Service Bulletin

Bulletin No. 2009-70R1
CMD 2009-10R1

Replacing an Existing HH or IH Pod Drive with a Zeus 3000 Series Pod (JH) Drive

a - Seacock—HH and IH
b - Seacock—3000 Series

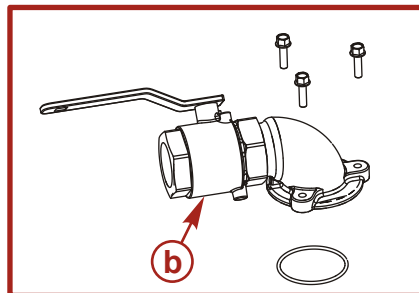
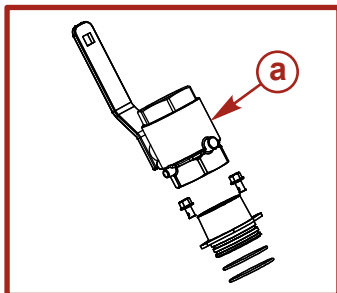
- The seacock on the 3000 Series pod drive is not interchangeable with earlier HH and IH model seacocks. The new seacock will need to be ordered separately from Mercury Marine and must be installed after the drive is in the boat and the clamp ring is installed. The new seacock mounts to either the port or starboard side of the drive. The part numbers for the seacocks are:

Description	Part Number
51 mm (2 in.) seacock	879150A63
64 mm (2-1/2 in.) seacock	879150A64

3000 Series Pod drive cover changes

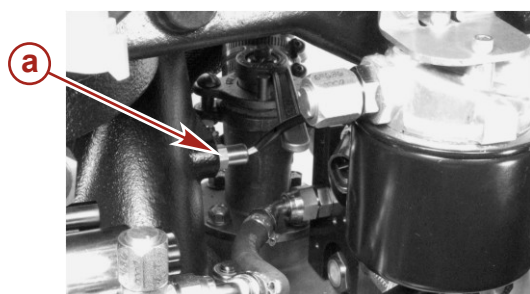
- The drive cover (shroud) from an IH model will fit on a 3000 Series pod drive model, except those models equipped with a cold water cooler. The IH cover blocks some of the service access points on the 3000 Series pod drive. Changing the cover to a new 3000 Series cover will provide proper service access and will fit models with a cold water cooler. The new covers can be ordered from Mercury Marine.

Description	Part Number
Zeus 3000 Series pod drive cover kit	879150A70

Exhaust temperature sensor relocation

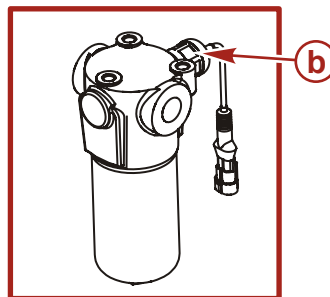
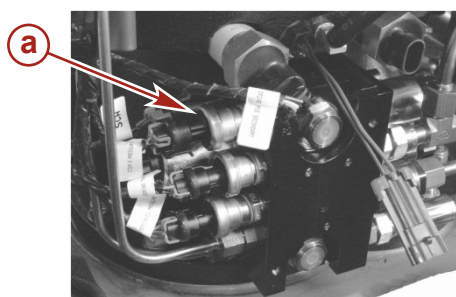
- The exhaust temperature sensor is not mounted on the 3000 Series pod drive. The exhaust temperature sensor on the HH and IH pod has been relocated to the engine exhaust. Contact CMD Customer Service if the exhaust temperature sensor is mounted on the steering actuator of an existing pod.

- a** - Drive mounted—HH and IH
- b** - Engine mounted—3000 Series pod

Oil system pressure sensor relocation

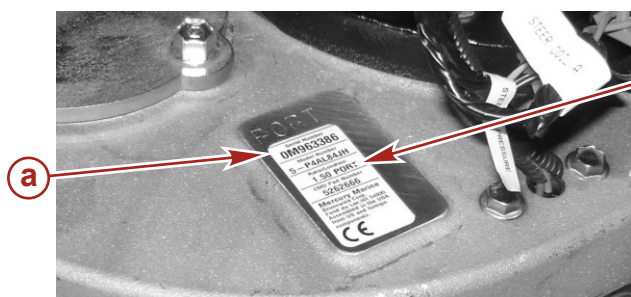
- The tank pressure sensor was removed on the 3000 Series pod drive because the return oil low-pressure filter system was replaced with a high-pressure filter system. The high-pressure system uses a pressure differential switch to generate a "filter clogged" fault if the filter clogs. In the absence of a pressure differential switch on the HH and IH drive, the TVM will check the tank pressure circuit instead and VesselView will not generate the "filter clogged" fault.

- a** - Tank pressure sensor—HH and IH
- b** - Pressure differential switch—3000 Series Pod (JH)
